# UNITED STATES PATENT AND TRADEMARK OFFICE

10/826,432

<b>Office Action Summary</b>	<b>Application No.</b> 10/826,432	<b>Applicant(s)</b> KASTRUP ET AL.	
	<b>Examiner</b> ANDREW NGUYEN	<b>Art Unit</b> 3746

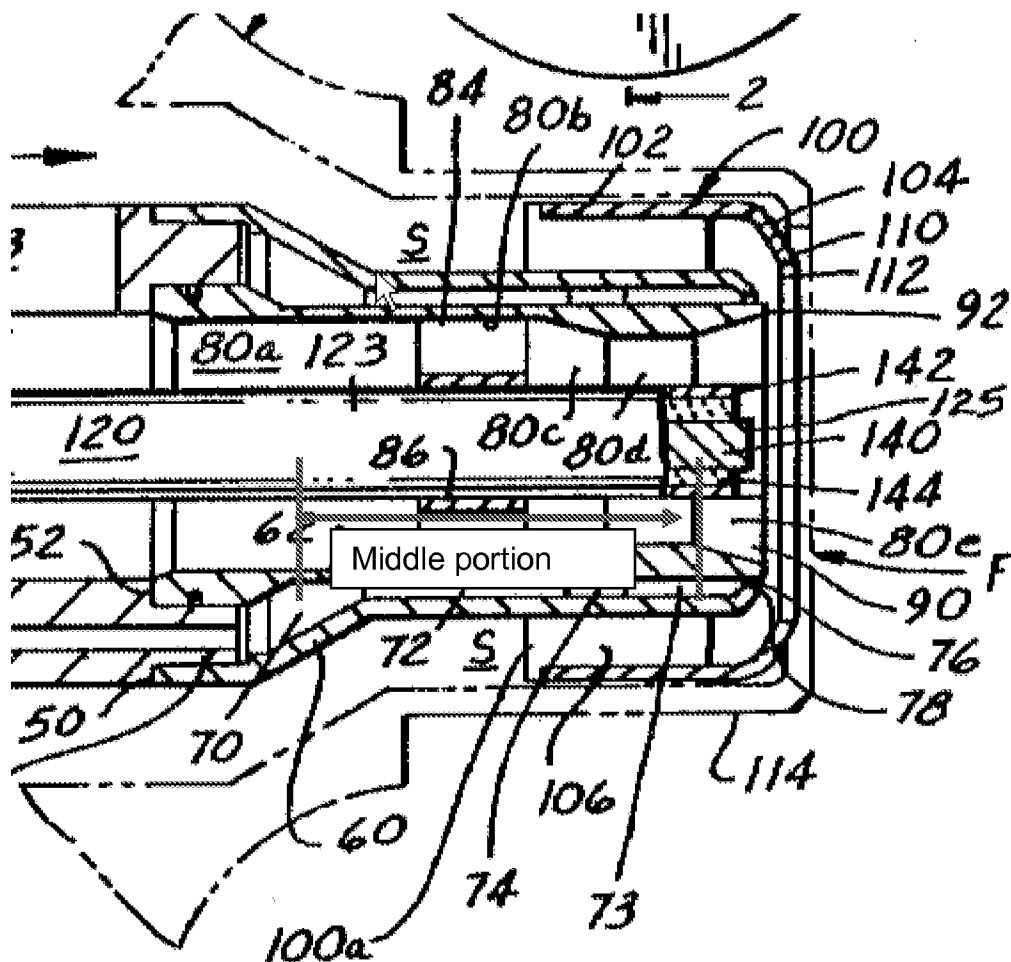
5. Claims 7-8, 13-15, and 18-20 are rejected under 35 U.S.C. 102(b) as being anticipated by US Patent 4,938,019 to Angell et al (Angell).

*a venturi (62 – defined by Angell as “sleeve extension”, but the venturi is included in the sleeve extension structure, i.e. the sleeve extension defines the venturi chambers, and thus, is considered a part of the venturi) comprising an upstream portion, a downstream portion and a middle portion (see definition of portions in Fig below) extending therebetween; and*

*a secondary swirler extending circumferentially around said venturi (100, 106, 60 – all parts of the secondary swirler), said secondary swirler coupled to said venturi (swirler 60 coupled to venturi 62 by wall 54) to substantially prevent fluid flow between a radially inner surface of said secondary swirler and a radially outer surface of said venturi at said upstream and downstream portions (“to substantially prevent ...” does not provide a clear limitation; how much is a "substantial" amount?), a gap is defined between said radially inner surface of said secondary swirler and said radially outer surface of said venturi middle portion (gaps 73, 72)*

With regards to applicant's arguments for claims 7 and 14, that "Angell does not describe nor suggest a swirler coupled to the venturi to substantially prevent fluid flow ... wherein a gap is defined between the ... swirler and the ... venturi at a middle portion of the venturi", it is noted that Angell does teach a swirler coupled to the venturi (see rejections of claims 7 and 14 above). The phrase, "to substantially prevent fluid flow ..." is very general in nature and does not specifically present a limitation. It is not known what constitutes a "substantial" amount. It is further noted that Angell does teach a gap between the swirler and venturi that occurs at a middle portion of the venturi (see Fig from rejection of claim 7 above).

However, Examiner asserts that Angell still anticipates the claim. The "annular fuel flow path" constitutes a gap between the swirler and the venturi. The gap also occurs along the full length of the venturi, which includes a middle portion. Finally, the venturi and swirler are coupled together via a body 54.
